APPEAL FORM

I am appealing the decision for the Front Yard Interpretation to designate Bette Ave. as the front lot line. Currently, their set back is over 14's from our property line. This is the same setback for our across Bette Ave. neighbors. They, have the same front of the house

RE: 10550 Bette Avenue, Cupertino, CA 95014

The roof line and beinge wall plus camphor tree is 10550 Bette Avenue as seen from the backyard of 6693 Clifford Drive.

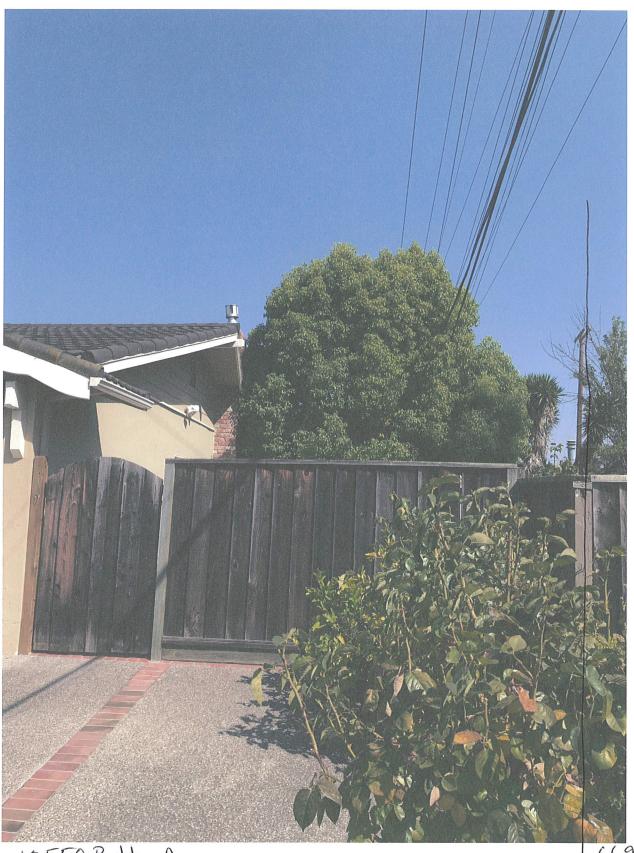
Benjamin Fu, hearing officer, heard our concerns but would not respond to them. I am also concerned about the camphor tree being removed and the encroaching setbacks, including a 2nd story. Please see spictures attached and meeting notes with neighbor. Therefore the concerned a follow-up with questions from me that is
